PROBLEM:**NOTE:** For related information, see Bulletin SER 73 2-16, Oil Pan Modification.

On production Z1's before engine Z1E02984, the oil pressure warning light may come on and stay on under certain driving conditions. This most often occurs when the oil is hot and the motorcycle is rapidly accelerated. If the oil pressure warning light comes on, oil flow is cut off from the engine by the pressure switch. Sometimes this blockage can be overcome by revving up the engine (6,000 + rpm).

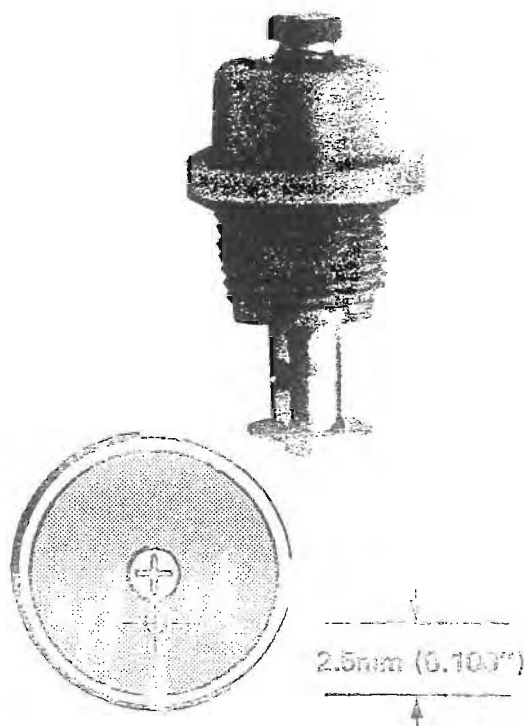
To prevent this problem from occurring, pressure must be relieved at the oil pressure switch. As long as flow is continuous through the switch, the oil pump will pick up oil and operate normally. By drilling a small 1/16" (1.5mm) hole in the bottom plate of the oil pressure switch, continuous oil flow is maintained and the oil pressure light will not stay on. The oil pressure light may flicker at high rpm, but the oil flow continues to the engine.

This hole is a standard factory modification to the oil pressure switch beginning with engine number Z1E-02984. Before this engine number, all oil pressure switches must have this hole drilled.

1. Disconnect the blue wire from the oil pressure switch.
2. Remove the oil pressure switch.
3. Mark and center punch the plunger disc at 2.5mm (0.100") from the edge. Drill a 1/16" (1.5mm) hole at this point.

CAUTION: Do not use a larger drill size, and make the hole location as precise as possible.

4. Re-install the switch and connect the blue lead.
